Peshastin Irrigation District Pump Exchange Project, Preliminary Design

RTT Comments and Applicant Responses

Project Number	PRISM 16-1787
Project Name	Peshastin Irrigation District (PID) Pump Exchange, Preliminary Design
Sponsor	Chelan County Natural Resources Department

Figure 3

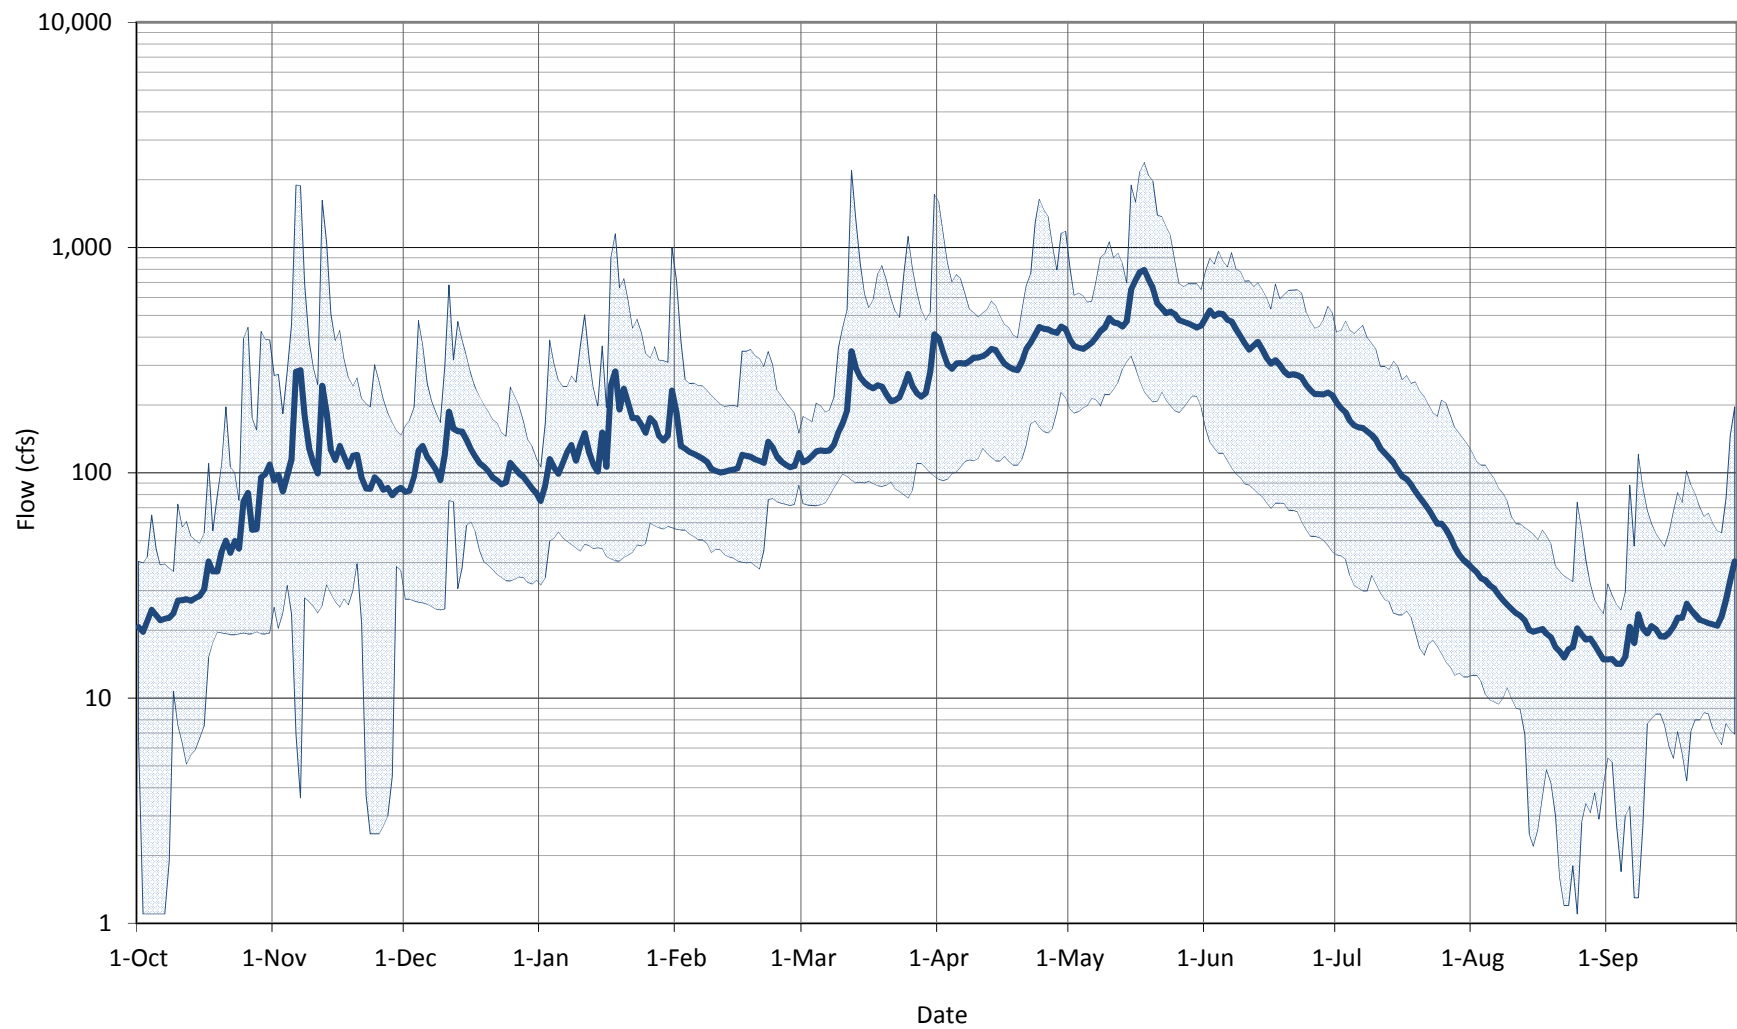
Casey – run that data through hydrograph to show how often that will happen, when it will happen in drier years, gives more operational certainty.

- Figures 3 and 4 were added to provide additional background about the hydrology in Peshastin Creek.
- Reference to “conceptual” design were changed to “preliminary” design because the intent is to carry the design forward to the 30% complete stage.

Response: See previous responses. Additional hydropgraph data is provided with the revised proposal.
